PRODUCT SAFETY RECALL #20170925

CORROSION THICKNESS PROBE HOLDER Part numbers PHS046, PHS056, PHS060 sold prior to September 25, 2017.

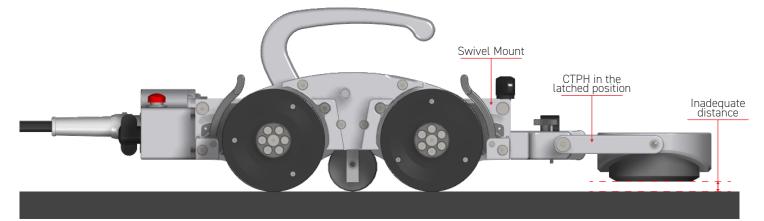
- · Operating a motorized crawler at height with a CTPH attached; and
- the Swivel Mount is locked in a position such that adequate upward travel of the CTPH is not possible due to the latch mechanism (see diagram below); and
- the crawler is driven over a weld or through a dip such that the CTPH pries the crawler off the inspection surface; and
- · proper tether is not used; and
- a person trespasses the required No Entry Fall Zone and is struck by the falling crawler.

The design defect does not allow adequate upward travel of the CTPH before it latches, which makes proper positioning of the Swivel Mount for adequate upward travel not obvious.

- 1. Fill out an RMA form found on our website at www.jireh-industries.com/support with "Product Safety Recall #20170925" in the "Description of Problem" field.
- 2. Ship the CTPH only (we do not require the crawler) to us following the shipping instructions we will provide after receiving the RMA.

Jireh will rework the product and ship it back to you free of charge.
